<b>Subject:</b> <b>SEAT BELT COMES OUT OF SEAT BELT GUIDE WHEN RETRACTING</b>	<b>Bulletin No:</b> 08-002/16
	<b>Last Issued:</b> 04/29/2016

2016 MX-5 vehicles with VINs lower than JM1ND\*\*\*\*\*108746 (produced before December 14, 2014)

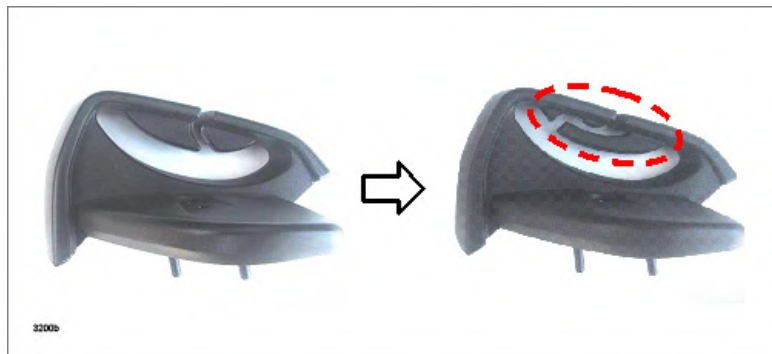
Some customers may complain that the seat belt comes out of the seat belt guide when the seat belt retracts as shown because the shape of the seat belt guide is inadequate.

To correct the problem, the shape of the seat belt guide has been changed.

1. Verify customer concern.
2. Remove two philips head screws on the seat belt guide, then replace the seat belt guide with a modified one (both sides).
3. Verify repair.
